**UNITED STATES  
NUCLEAR REGULATORY COMMISSION**  
WASHINGTON, D.C. 20555-0001

SUBJECT: RESUBMITTAL OF REQUEST FOR ADDITIONAL INFORMATION FOR THE  
MODEL NO. LEUPA PACKAGE

**Resubmittal of Request for Additional Information  
Revalidation Review  
Docket No. 71-3090  
Model No. LEUPA**

**Picture 27: Primary containment flange after tests**

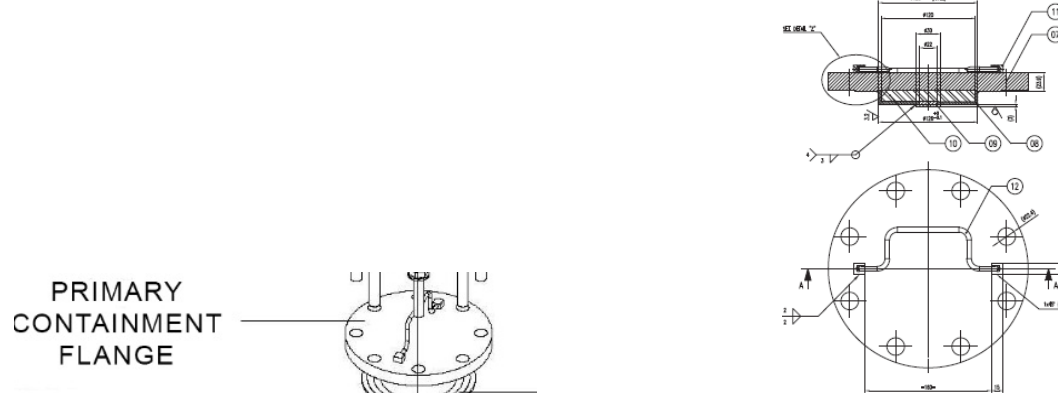
**G-Sh-1.** Revise the application's description of the "Primary Containment Lid/Flange."

The previous question regarding this item has not been adequately answered. The figure of concern is Picture 27 of the "Tests Final Report" document (shown here).

The picture above (i.e., figure) does not appear to be of or about the primary containment flange per the discussions and per the figure submitted in the RAI responses. It is not clear what this component is. Based on the figure submitted in the RAI responses, the metal object shown in the foreground of the picture, is not part of the packaging since that figure does not include it. It is also not clear that the design drawings include this metal object either. If this metal object in Picture 27 is the primary containment flange, then the submitted figure and the English version of the figure that is on page 27 of 30 of the Safety Report (Document No. 002 0908-LE00-3BEIN-023-A) (see cut out of figure from Safety Report page 27 of 30 below) and the design drawings (see a cut out of Drawing No. 00B 0908-LE01-3AEIN-005-A below) are not correct and must be fixed because these show the primary containment flange as a solid lid with a handle and a cadmium component (whereas this Picture 27 has a large hole in the

middle of the flange). The object with a handle in Picture 27 appears to be the top most of the four inner cans that are loaded into the package.

Safety Report (page 27 of 30); Drawing No. 00B 0908-LE01-3AEIN-005-A
